Title	FSB 233-007, Fuel Filter Housing, Replacement; Extra Port On Fuel Filter Housing When Replacing With New Part - Vehicles Manufactured Between 14 November 2016 And 31 December 2019
-------	---

23393-9 FSB 233-007, Fuel Filter Housing, Replacement

(April 2020)

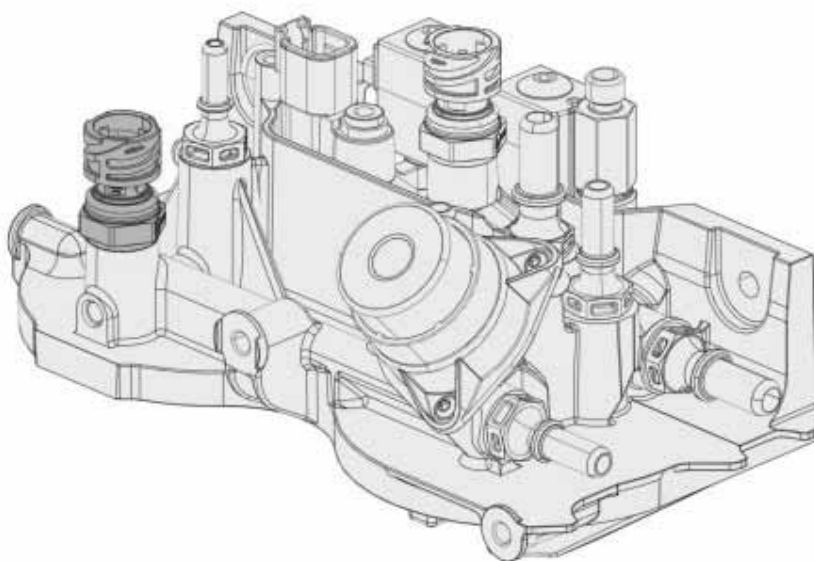
All Volvo vehicles built with 11L or 13L engines, between 11/14/2016 and 12/31/2019, that need to have the fuel filter housing replaced, will get superseded to a new part that will require the installation of a plug in the second sensor port.

The superseded fuel filter housing will contain a port for a second fuel pressure sensor.

On trucks built before 1/1/2020, the software does not support the functionality of this new sensor.

Note: If the fuel filter housing is replaced with any of the following part numbers, follow the steps in this bulletin to correctly block the sensor port.

To replace the fuel filter housing, follow the standard repair procedure [23327-2 Engine Fuel Filter Housing, Replacement](#)

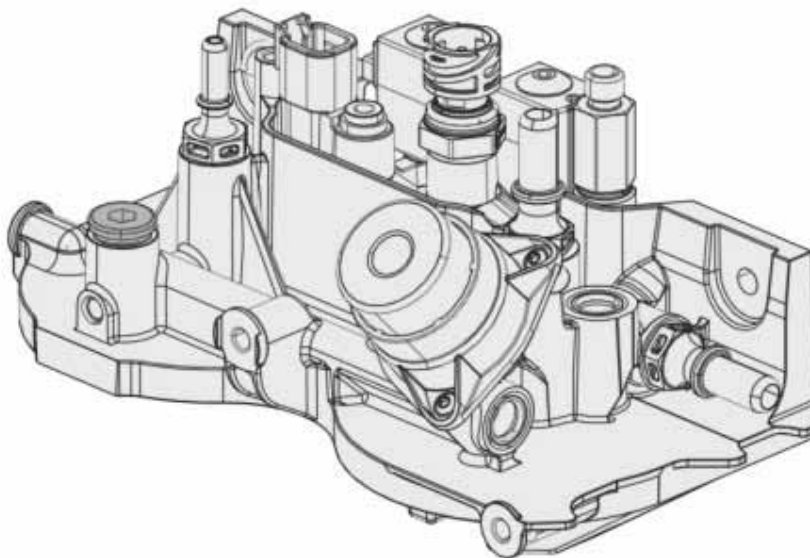
1. Remove the fuel pressure sensor from the secondary fuel pressure sensor port.

2. Install the plug into secondary fuel pressure sensor port.

Tightening torque	
Plug, secondary fuel pressure sensor port (M16)	25±3 Nm (18.66 ft,lbs)
